West Coast Regional Council  
PO Box 66  
Greymouth 7840

16 August 2022

**Section 92 letter RFI-Hokitika Seawall RC-2022-0039 AND RC220053**

Figure 7 – Rock revetment section – higher toe level

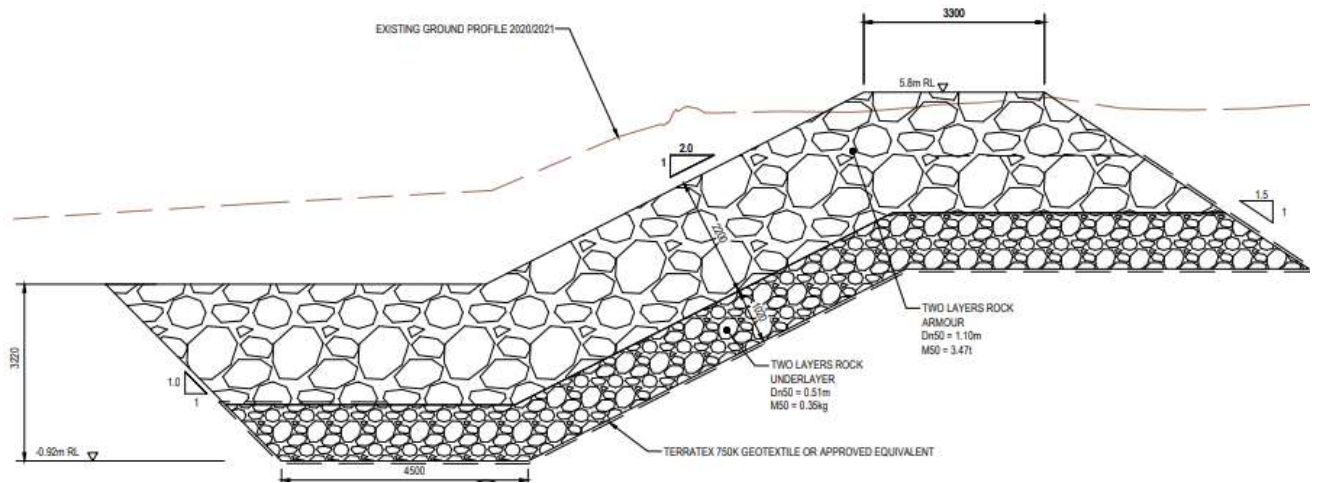
- **The potential visual impact on adjoining properties regarding the height of the sea wall, being higher than current ground height as demonstrated in Figure 3 2 Cross section of seawall higher toe height.**

Figure 3-2 shows that that the difference between the lowest existing ground level and the top of the seawall is approximately 0.3 m which is considered to have an insignificant effect on adjoining properties given the following:

Figure 1b: Existing revetment, April 2021 (from GoogleEarth)

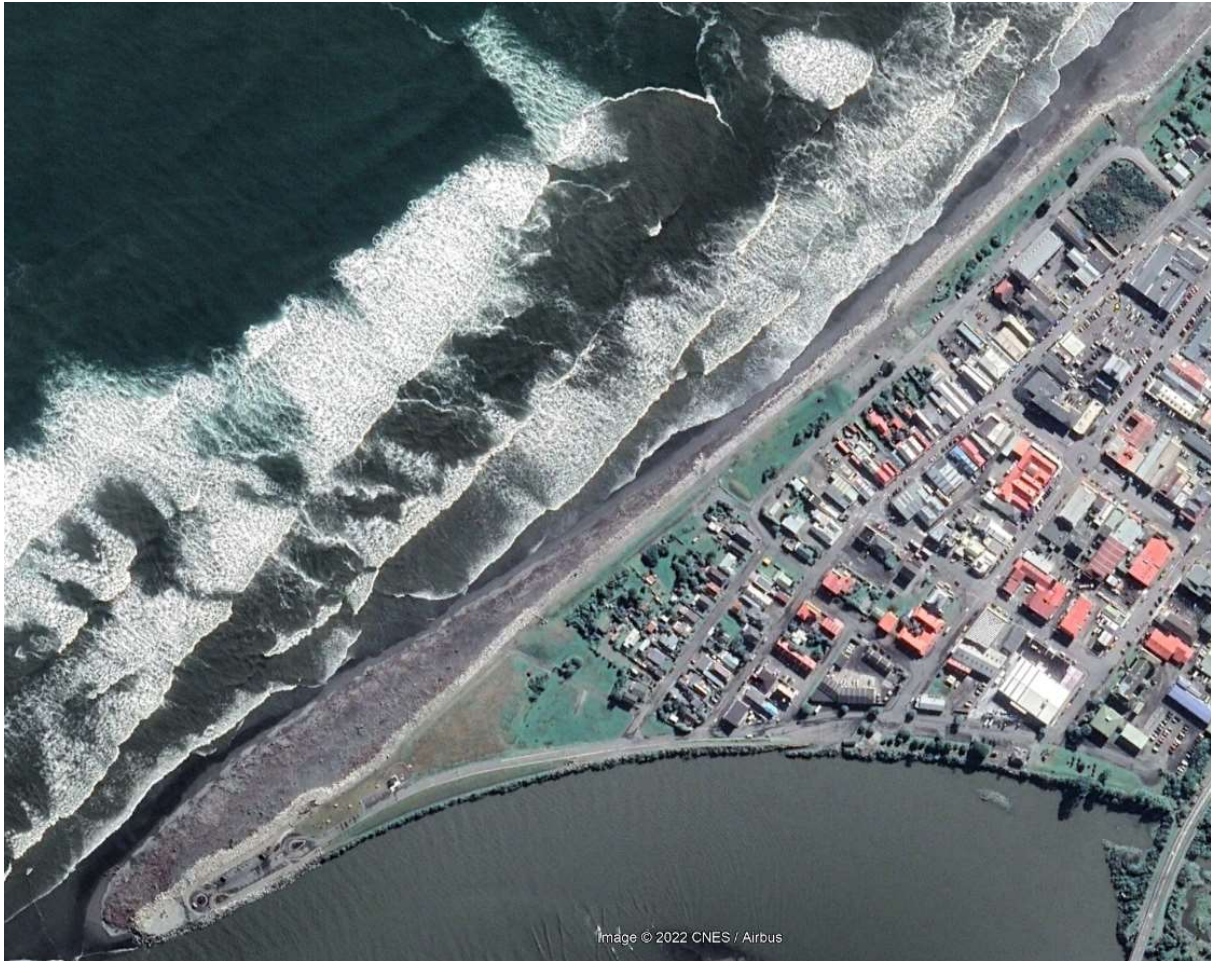
| Item  | Query/Clarification   | Addressed by / Reference   |
|---|---|--|
| AEE Section 5.4(b) effects on beach performance | No discussion on impoundment effect of the wall (and cumulative effects of this and adjacent wall) on shoreline evolution. Unless this is what you are saying in 5.4.6? With life of 10-15 years should you also consider removal as an effect? | AEE Section 5.4.6<br><b>Attachment 6</b><br>See also response to Question 3 in this letter |

The existing revetment presently interrupts the supply of backshore sediment in the area south of the proposed revetment extension. Site observations and historical satellite images indicate beach narrowing/ lowering/ steepening through the central and northern sections of the existing revetment and beach widening/ increase in levels/ flattening at the southern beach (refer to Figure 1a, 1b). As noted above, while the revetment extension remains covered with beach material, coastal processes are expected to continue as at present and cumulative effects of the existing and proposed revetments are expected to be similar to the existing revetment effects.

Once the revetment extension is regularly exposed, the cumulative effects of the existing revetment and proposed extension are expected to result in continued fluctuations in beach levels, with the beach trending towards a steeper, narrower, lower profile due to reduced sediment supply and increased wave reflection. The combined revetments potentially reduce the volume of sediment available to the net northerly longshore transport (Gibb, 1987), which may result in shoreline retreat and rollback of the coastal barrier north of the site. Based on shoreline movements between Stafford Street and Richards Drive over the 2013 to 2021 period following construction of the existing revetment, such effects might extend some 900m north of the proposed revetment extension.
